# Request for Quotation

RFQ NUMBER  
 PTR07010

LINE	QUANTITY	UOP	CAT. NO.	ITEM NUMBER	UNIT PRICE	AMOUNT
				ADDENDUM NO. 2		
				THIS ADDENDUM IS ISSUED TO ADD AND CLARIFY DRAWINGS, SKETCHES, AND SPECIFICATIONS TO THE ORIGINAL CONSTRUCTION DOCUMENTS AND TO ANSWER QUESTIONS RAISED AT THE MANDATORY PRE-BID MEETING AND THOSE RAISED PRIOR TO THE 12/28/2006 DEADLINE FOR QUESTIONS.		
				ALSO, TO EXTEND THE BID OPENING DATE TO ALLOW TIME FOR VENDORS TO INCORPORATE THIS INFORMATION INTO THEIR BID RESPONSES.		
				BID OPENING DATE IS EXTENDED TO: 01/18/2007 BID OPENING TIME REMAINS: 1:30 PM		
				***** END ADDENDUM NO. 2 *****		
0001	1	EA		968-20		
				CONSTRUCTION/RENOVATION

The following are clarifications from questions and comments from the Fairmont Marion County Transit Authority's mandatory pre bid meeting held on Thursday, December 14, 2006.

DRAWN: SCC	CHECKED: RMH
SCALE: AS INDICATED	
DATE: DECEMBER 8, 2006	
JOB NO. PR42410	
REF. SHEET S400	
DWG. NO. SKS-11

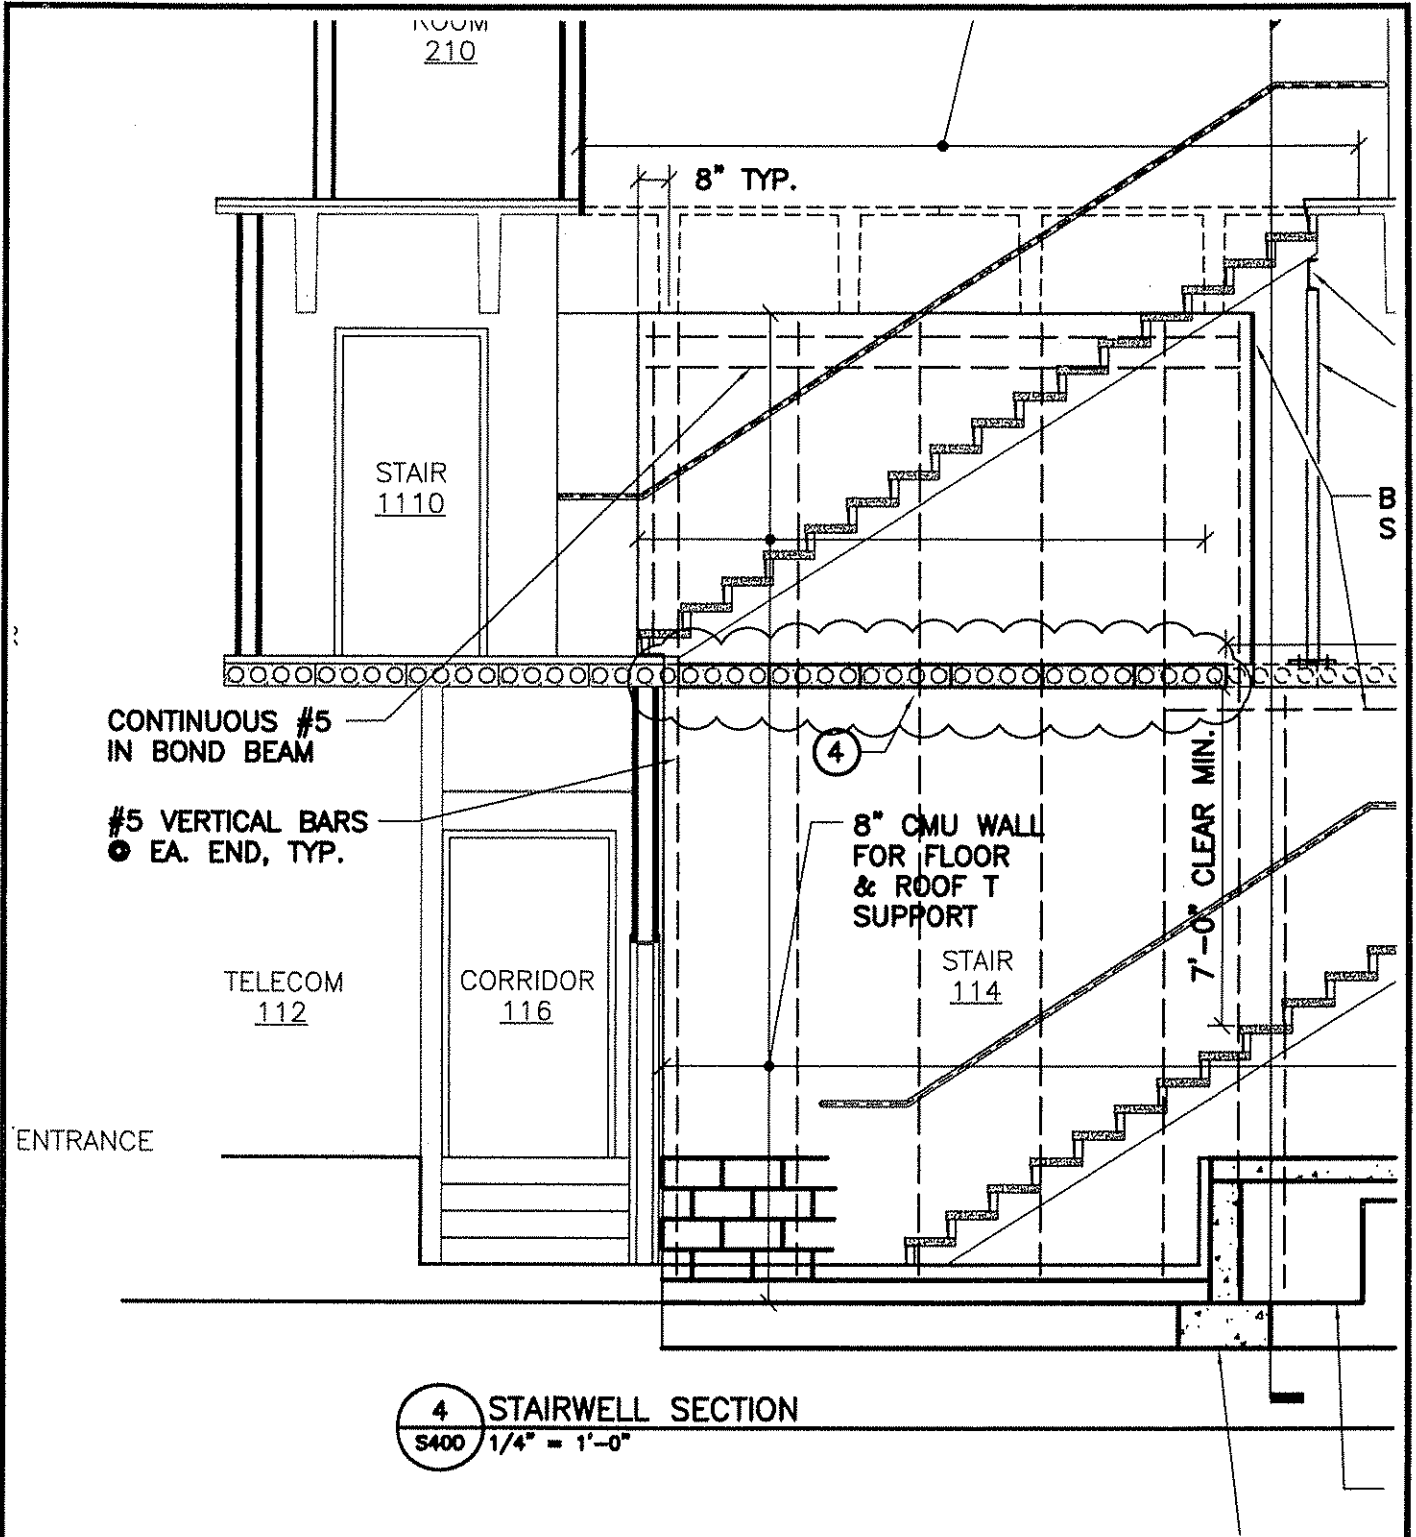
11. Sheet S400 **STAIR 114 PLAN AND SECTION:** Detail 3/S400;  
Delete Note: Saw Cut Double Tee Roof Deck 4'-1½" x 20'-0" for Stair Access.  
Add Note: Sawcut 8" Floor Plank 16'± for Stair Access. See Architectural Drawings.

DRAWN: SCC	CHECKED: RMH
SCALE: AS INDICATED	
DATE: DECEMBER 8, 2006	
JOB NO. PR42410	
REF. SHEET S401	
DWG. NO. SKS-12

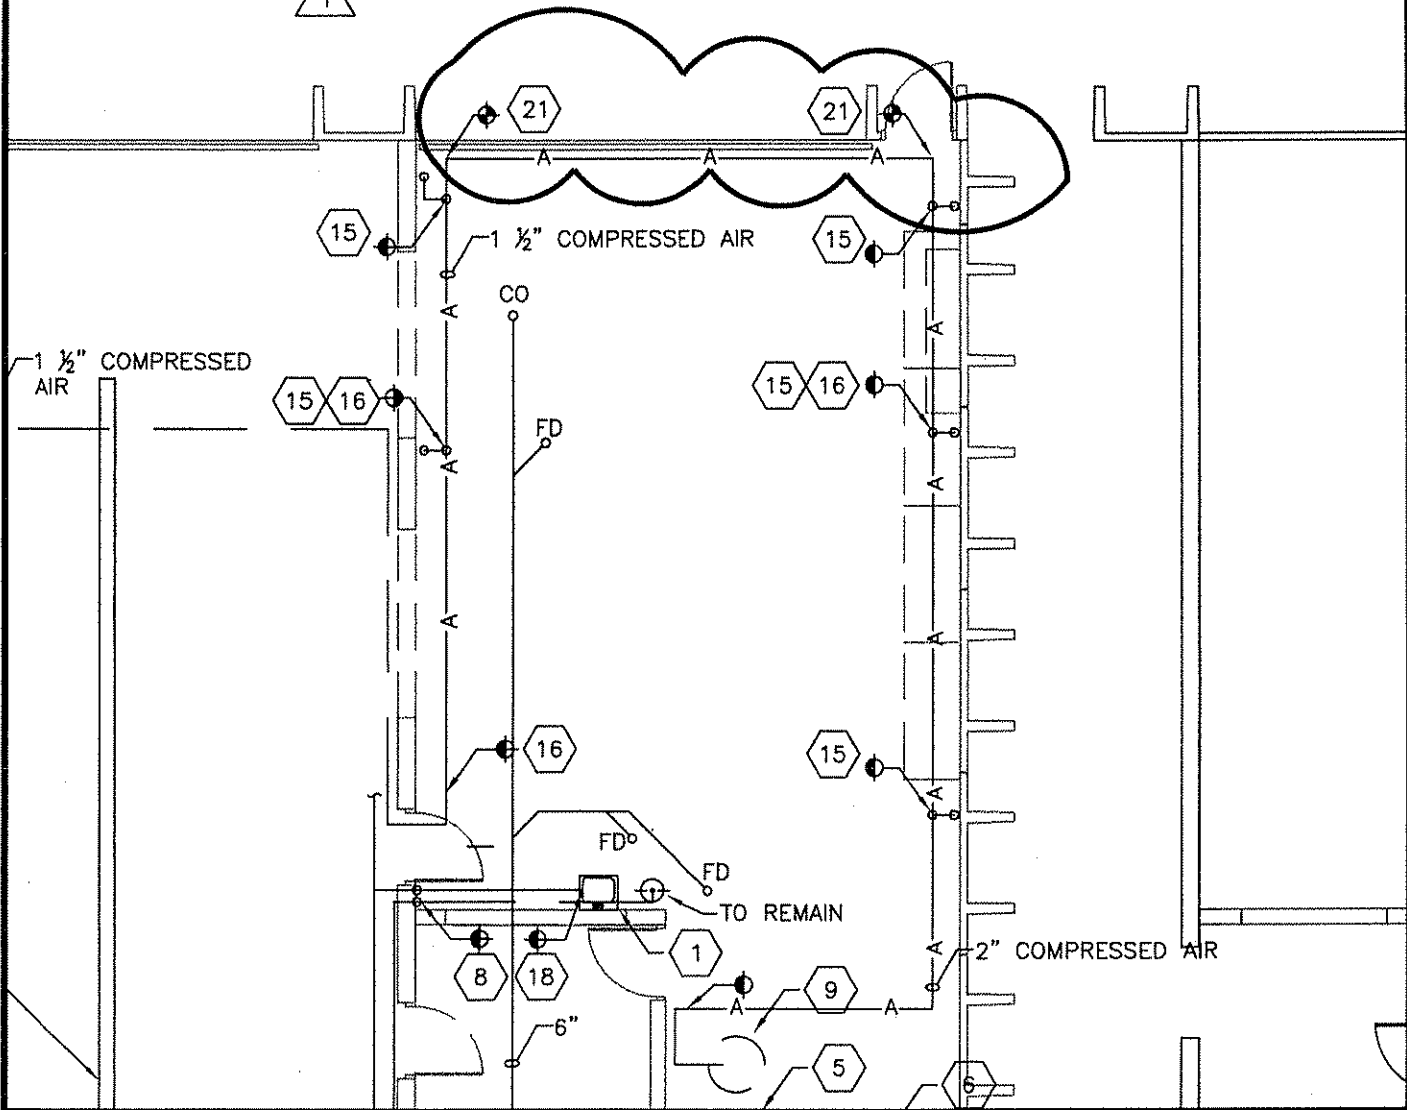
12. Sheet S401 **STAIR 114 DETAILS:** Detail 5/S401;  
Remove referenced notation for Lean Fill Concrete Under Existing Foundation of Existing Precast Double Tee Well.

DRAWN: JMW	CHECKED: LAC
SCALE: AS INDICATED	
DATE: DECEMBER 21, 2006	
JOB NO. PR42410	
REF. SHEET P101	
DWG. NO. SKP-1

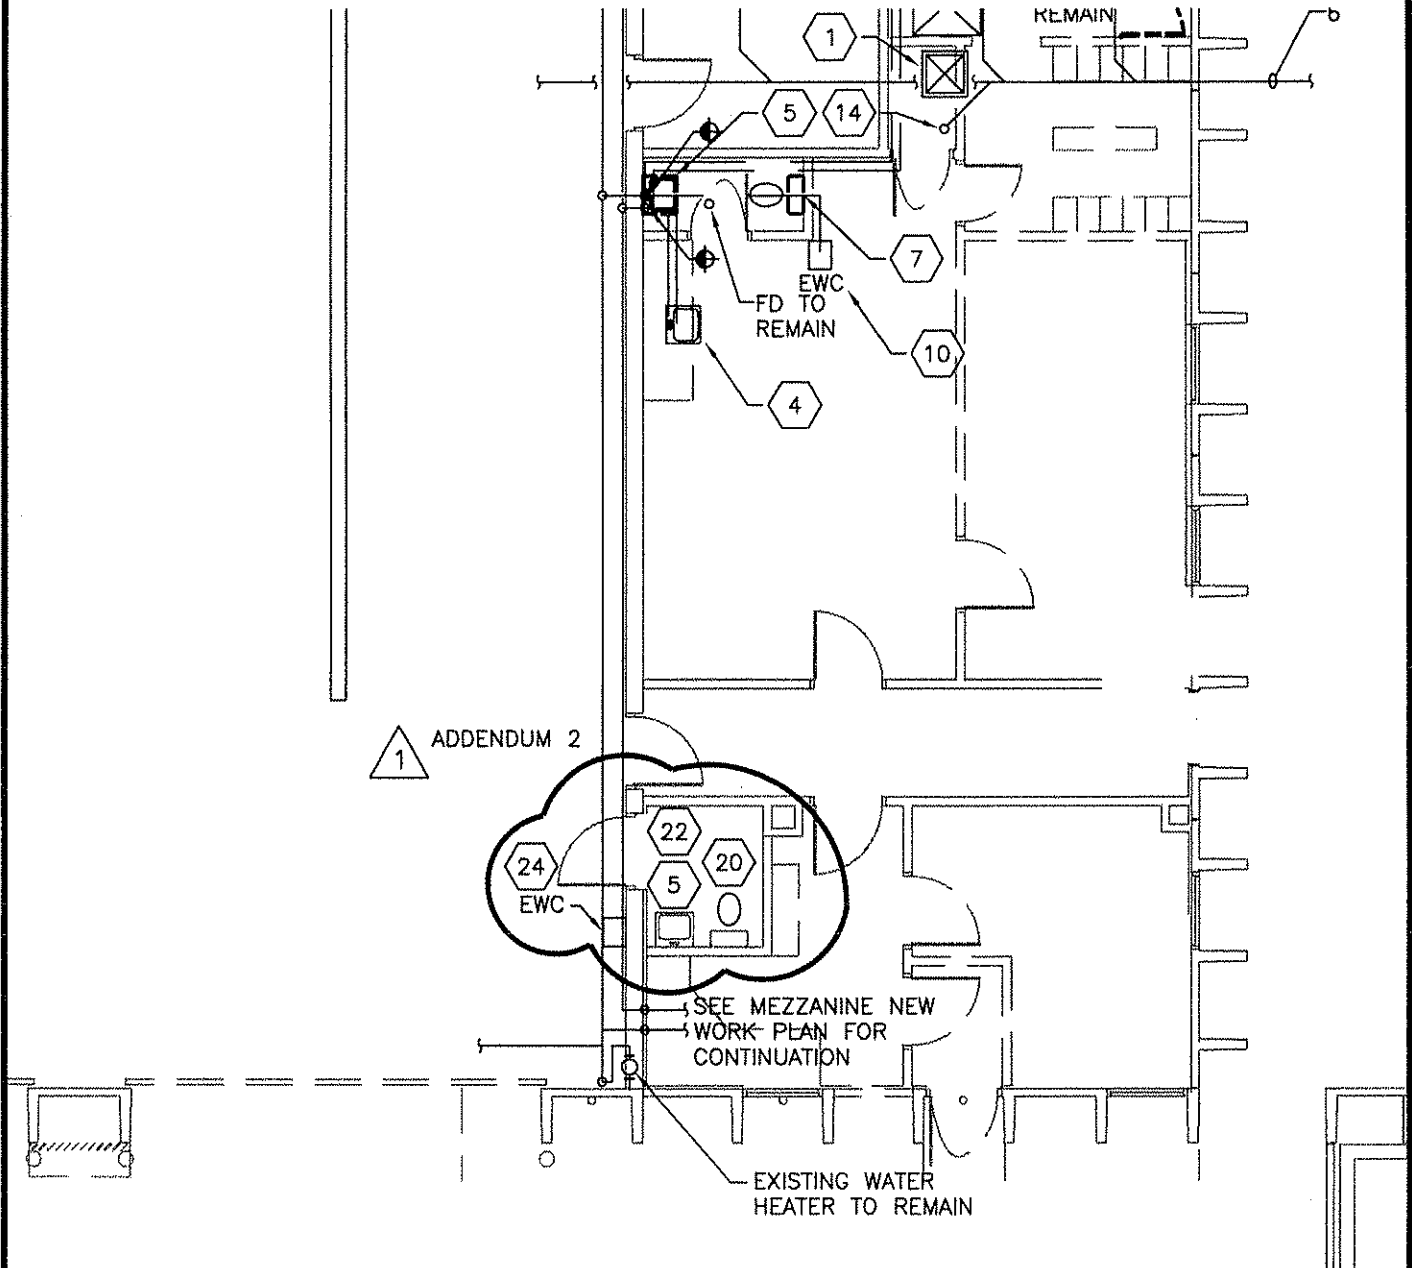
- 8. Sheet P001 in PLUMBING FIXTURE AND CONNECTION SCHEDULE tag "SP" SUMP PUMP in description horse power is 1/3.
- 9. Sheet P101. See sketches SKP-1, SKP-2 and SKP-3 for revisions.

DRAWN: JMW	CHECKED: LAC
SCALE: AS INDICATED	
DATE: DECEMBER 21, 2006	
JOB NO. PR42410	
REF. SHEET P102	
DWG. NO. SKP-4

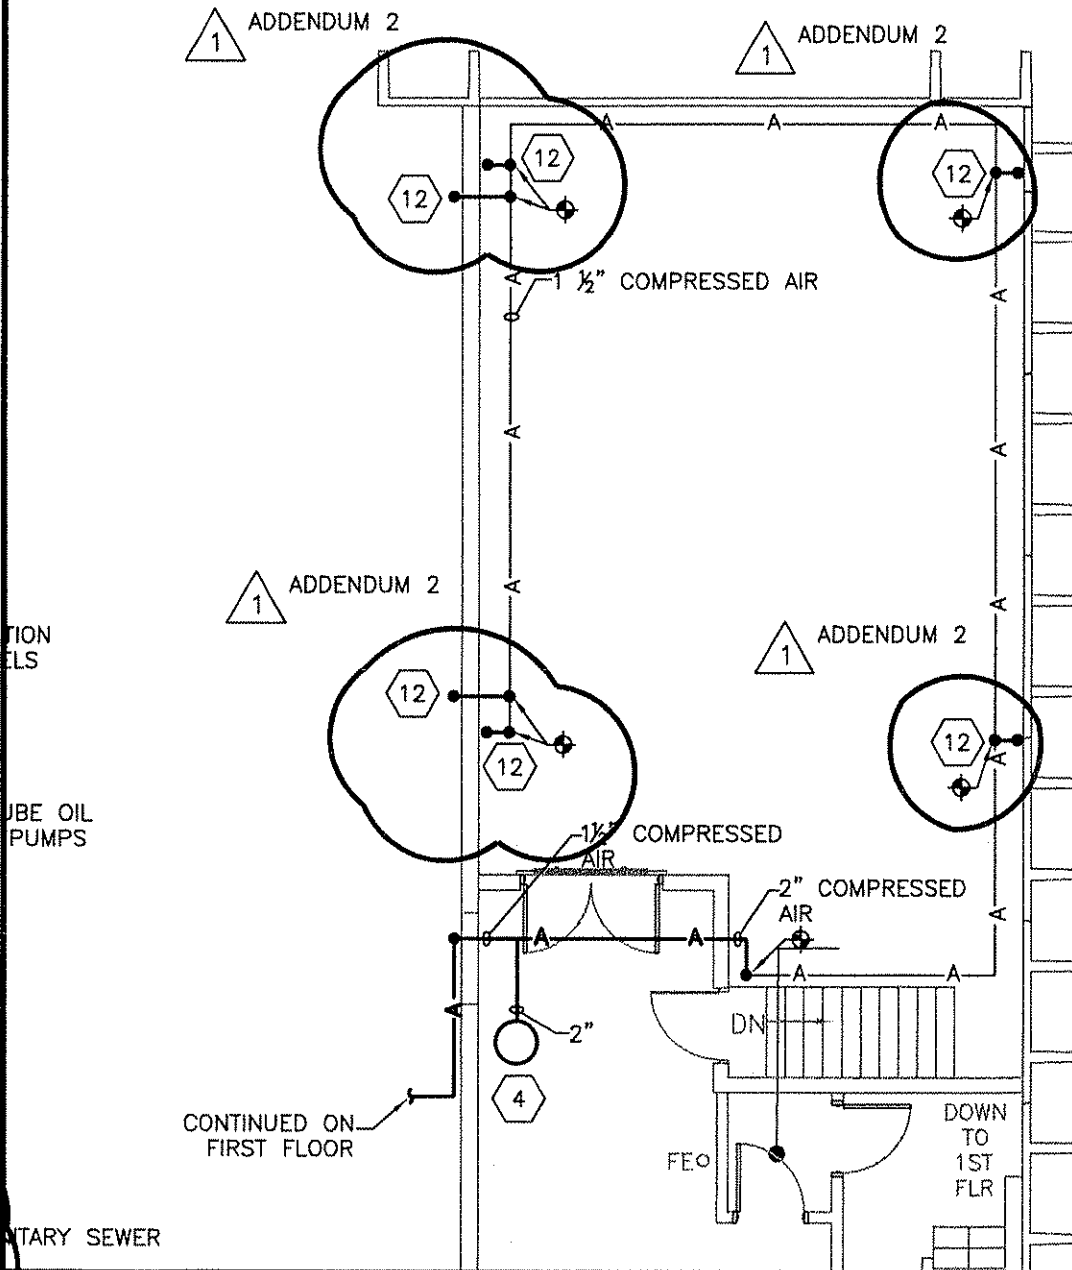
- 10. Sheet P101 sheet note 9, modify to read "REMOVE AIR COMPRESSOR AND TURN OVER TO OWNER."
- 11. Sheet P102. See sketches SKP-4, SKP-5 and SKP-8 for revisions.

DRAWN: JMW	CHECKED: LAC
SCALE: AS INDICATED	
DATE: DECEMBER 21, 2006	
JOB NO. PR42410	
REF. SHEET P301	
DWG. NO. SKP-6

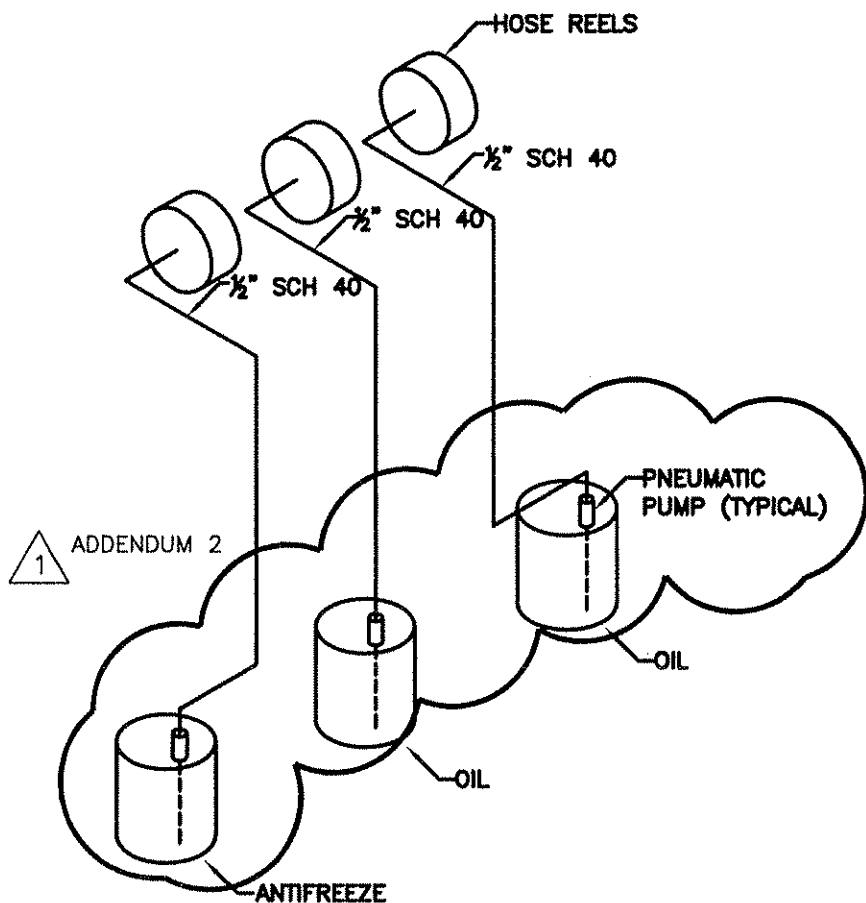
- 5. Sheet P001 under general notes paragraph that reads "PROVIDE TRAP PRIMERS AND TYPE "K" COPPER PIPING TO ALL FLOOR DRAIN, FLOOR SINK, AND HUB DRAIN TRAPS, AND OTHER TRAPS REQUIRING PRIMING WHETHER SHOWN ON DRAWINGS OR NOT" modify to read as follows "PROVIDE TRAP PRIMERS AND TYPE "K" COPPER PIPING TO ALL NEW FLOOR DRAIN, FLOOR SINK, AND HUB DRAIN TRAPS, AND OTHER TRAPS REQUIRING PRIMING WEATHER SHOWN ON DRAWINGS OR NOT", SEE SKETCH SKP-6.

- 13. Sheet P301. See sketches SKP-6, SKP-7 and SKP-9 for revisions.
- 14. Sheet M001 add to Mechanical general notes the following; "PROVIDE SUBMITTAL INFORMATION ON ALL PRODUCTS AND MATERIAL BEING INSTALLED AND SUPPLIED. PROVIDE ONE YEAR WARRANTY, PROVIDE INFORMATION ON PARTS AND LABOR. PROVIDE TRAINING ON OPERATION AND MAINTENANCE OF SYSTEMS PROVIDED AND INSTALLED."

DRAWN: CGR	CHECKED: CGR
SCALE: AS INDICATED	
DATE: DECEMBER 8, 2006	
JOB NO. PR42410	
REF. SHEET E600	
DWG. NO. SKE-1

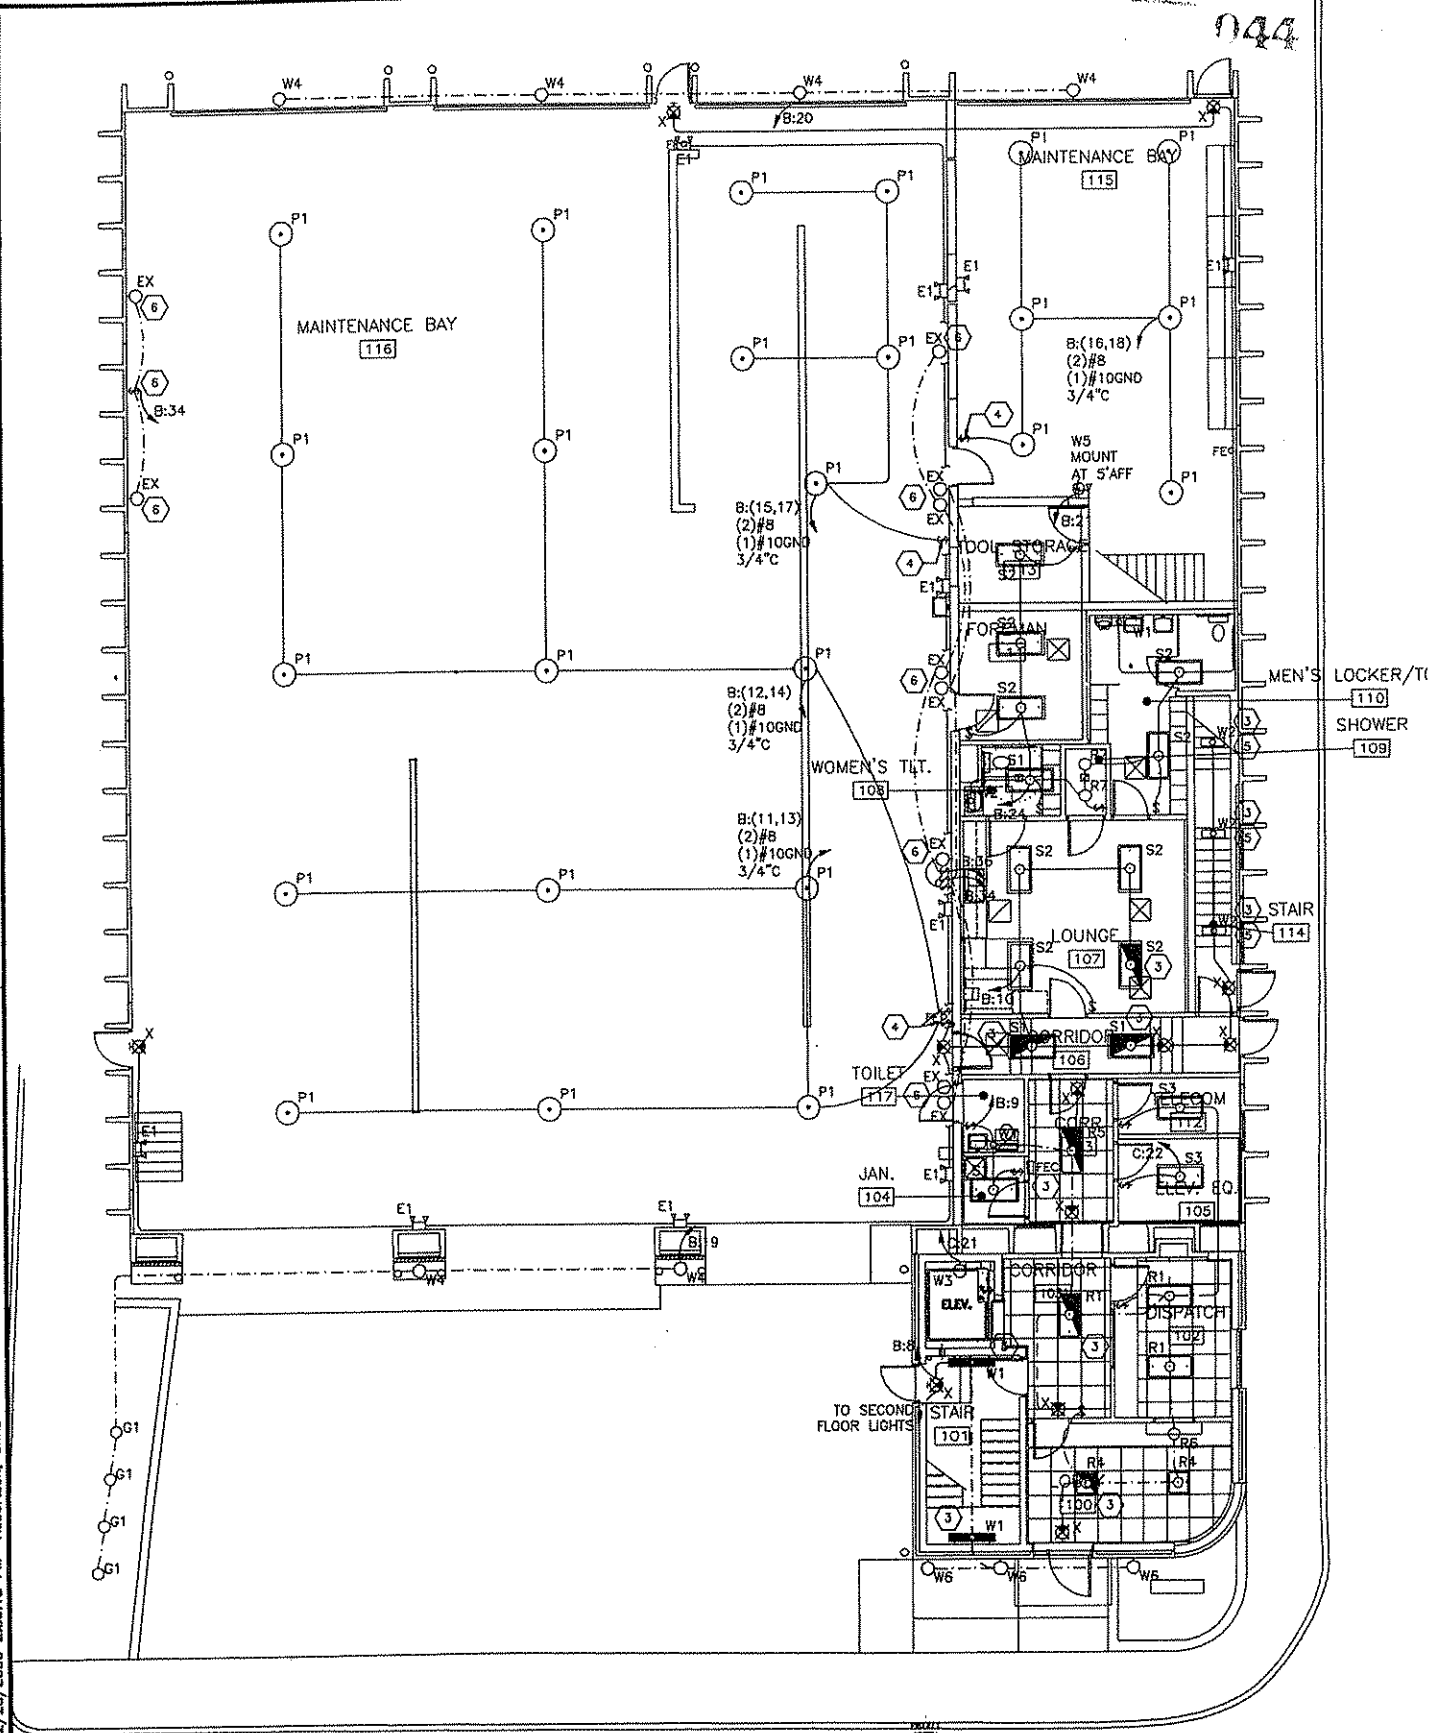
7. Sheet ED100 add electrical demolition note "16" to read – "SEE NEW CONSTRUCTION DRAWINGS FOR SELECTIVE ITEMS TO REMAIN FROM DEMOLITION."
8. Sheet E600 change circuit C:13 description from "ELEVATOR CAB" to "COUNTER RECEPTS ROOM 115".

9. Sheet E600 change circuit C:35 description from "SPARE" to "RECEPTS RMS 115,116".
10. Sheet E600 change circuit C:37 description from "SPARE" to "RECEPTS ROOM 116".

11. Sheet E600 change circuit A:1,3,5 description from "WELDING OUTLETS" and "SPARE" to "EXISTING VEHICLE LIFT RECEPTS" and change from a 60/2 and 20/1 breaker to one 60/3 breaker.

12. Sheet E600 change circuit A:10,12 description from "VEHICLE LIFT" to "EXIST WELDING OUTLET AND NEW TIRE CHANGER RECEIPT" and change 20/2 breaker to a 50/2.
